Rev	Date	Notes
A	9/10/2010	Created from 750-2152-001, changed input power sensing and enable circuitry, power changes to OMAP
B	10/11/2010	ECN-13172 - Changed U13, DNI R148, install board ID resistor R109, DNI Mic bias resistors, and change T/N for R165
C	10/28/2010	ECN-13183 - Changed resistor stuffing on JTAG connector
D	11/8/2010	ECN-13192 - Changed U14 IC to Schmitt-trigger device

OMAP4430 Panda Board, 8-Layer  
TWL6040 Audio Companion IC  
Document Number: 790-2152-002-SCH  
Date: Monday, November 29, 2010  
Sheet 4 of 14

OMAP4430 Panda Board, 6-Layer  
 Document Number 790-2152-002-SCH  
 Date: Monday, November 29, 2010

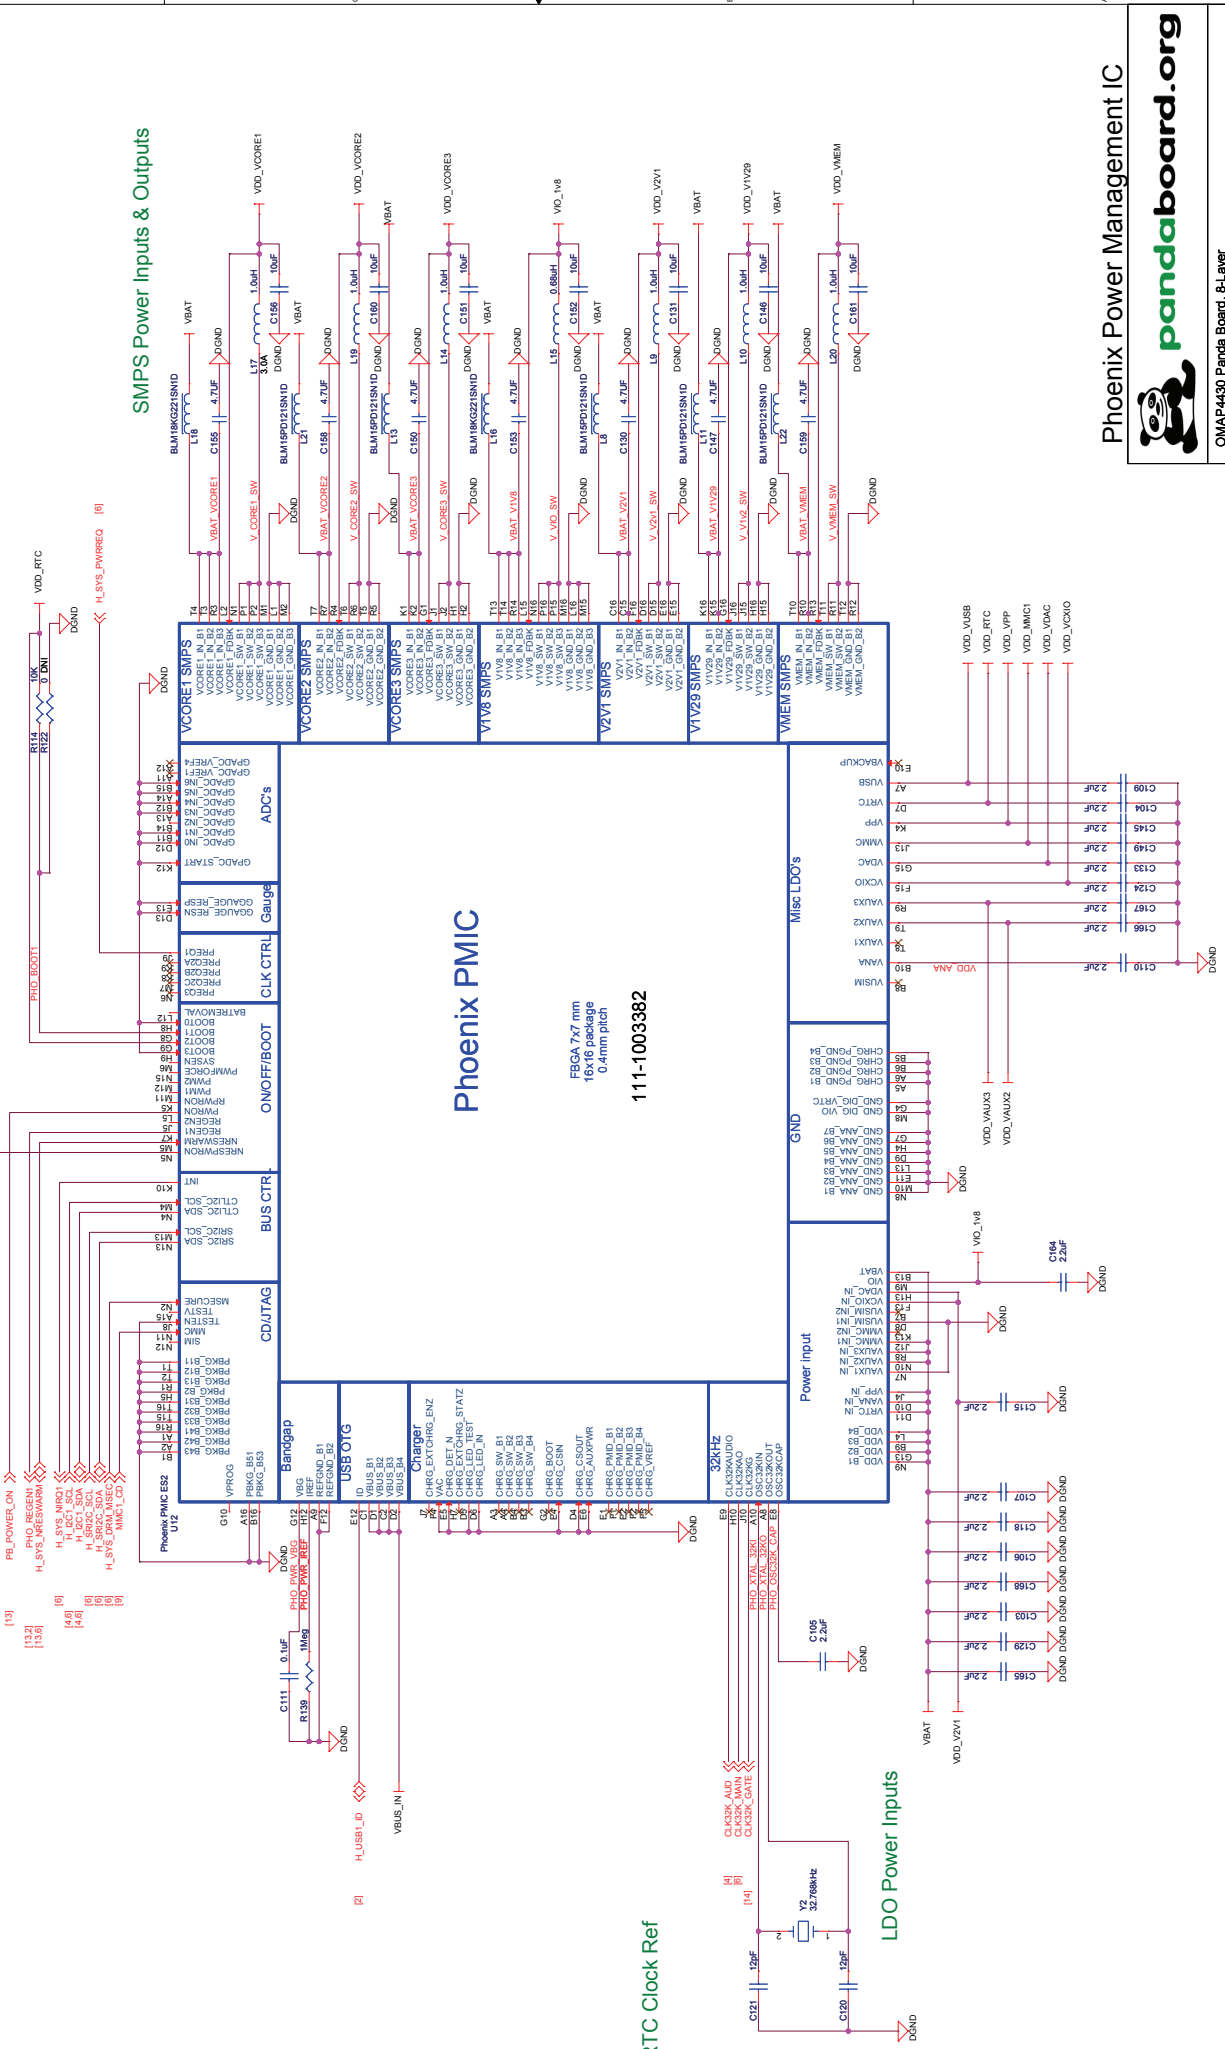
ECM-13192  
Changed U14 from a SN74LVC1G17DCKR to a SN74AUP1G17DCKR

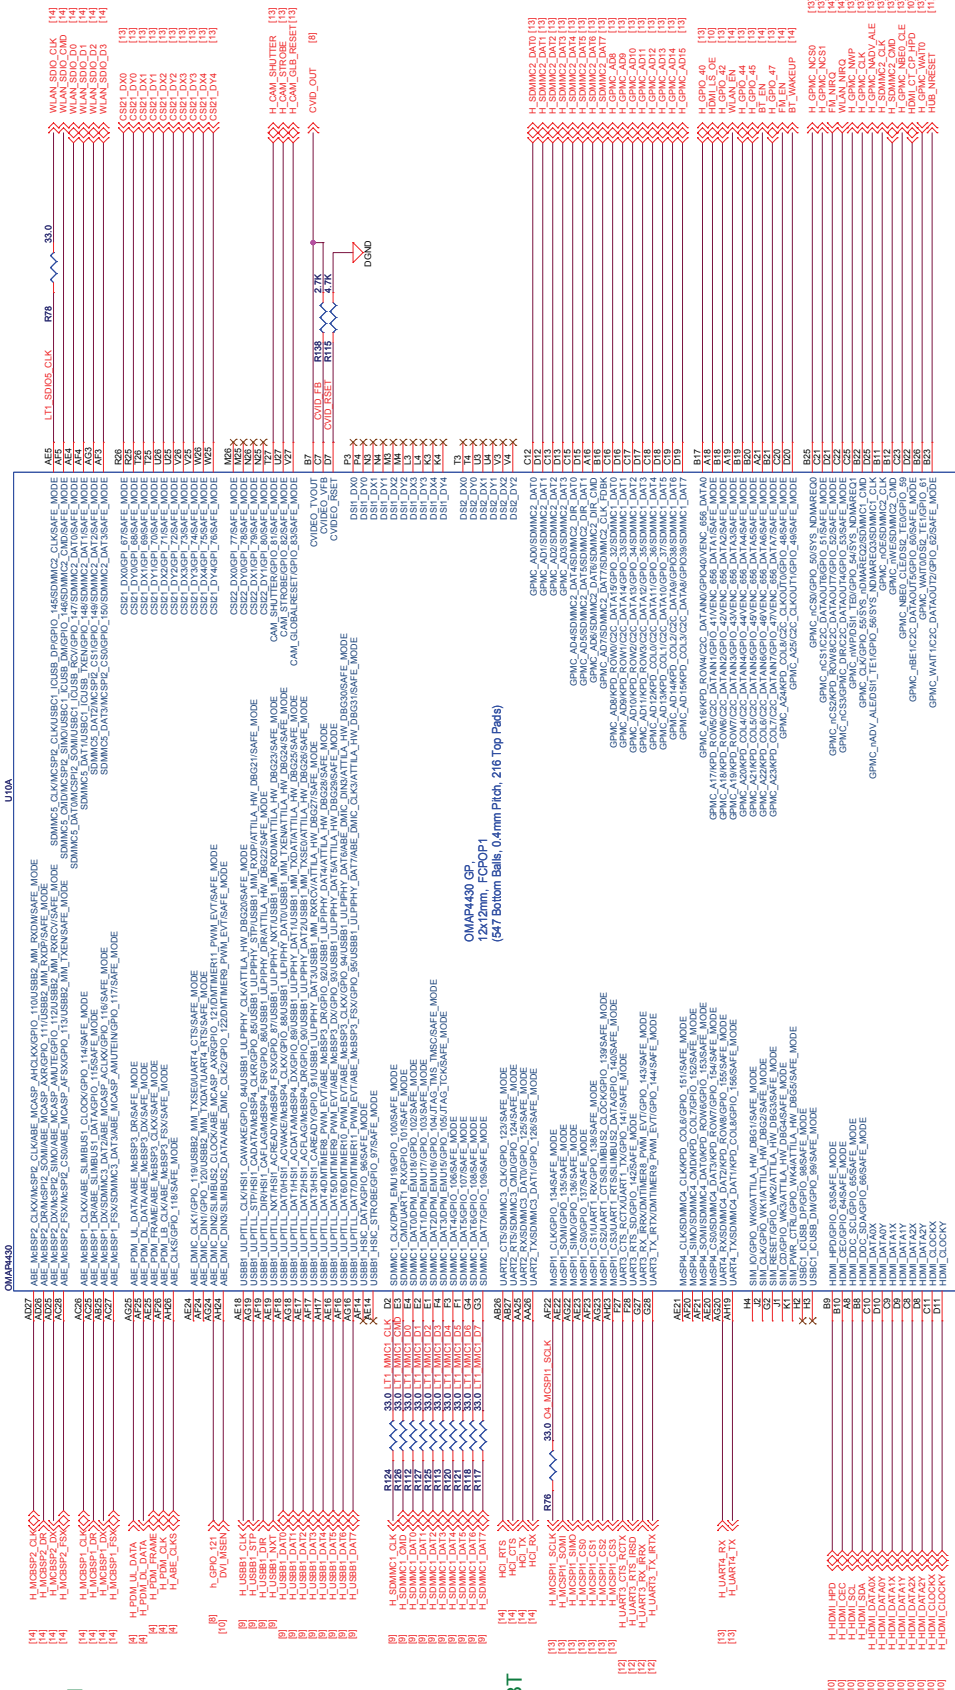
ECN-13172  
DNI R157, R159 and C184 (disconnect BIAS voltage)

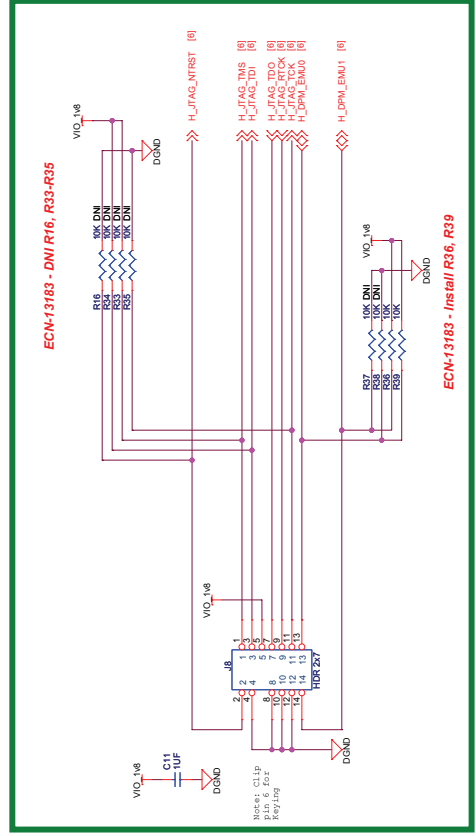
ECN-13172 - Install R109

OMAP4430 Panda Board, 6-Layer  
JTAG Debug Connectors

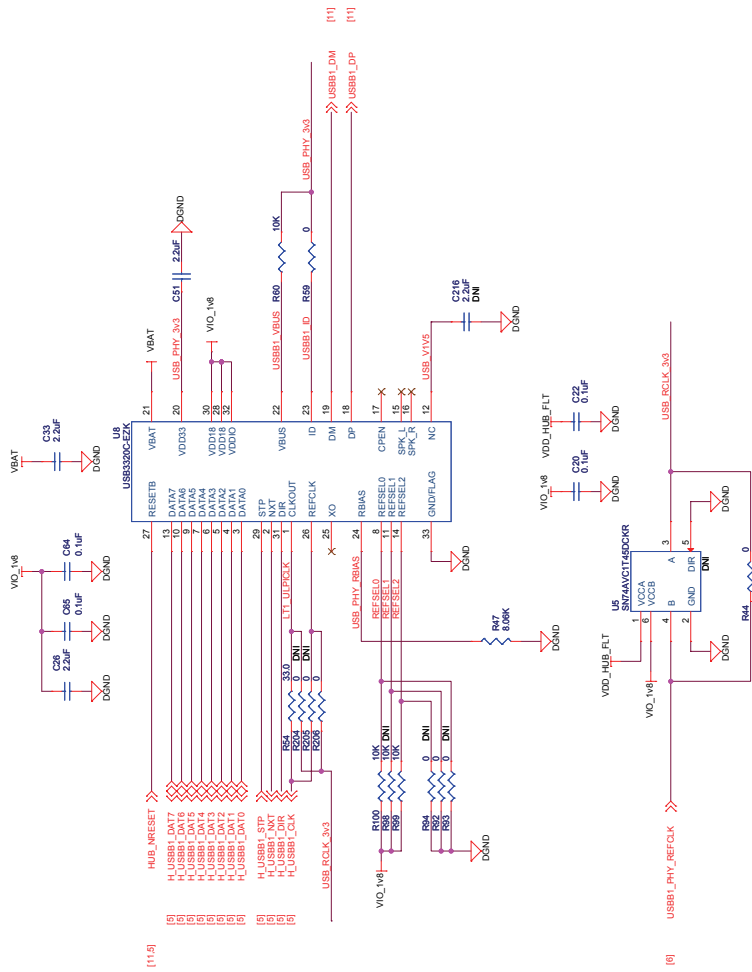
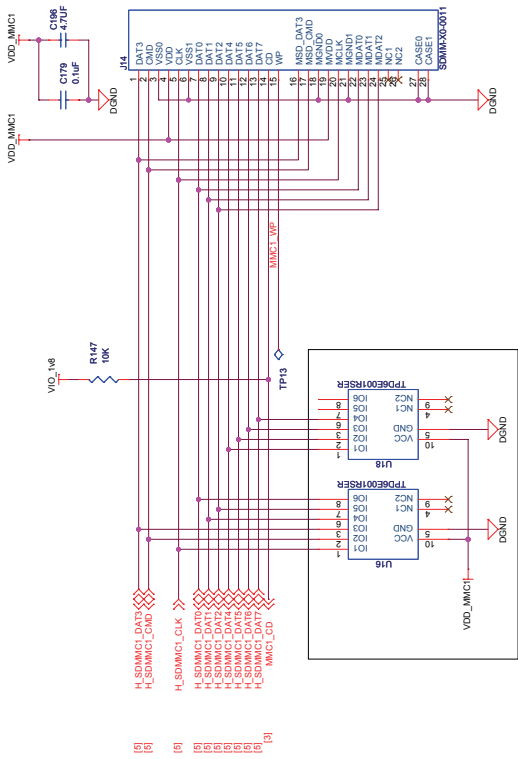
ECN-13183 - DNI R16, R33-R35

ECN-13183 - Install R36, R39
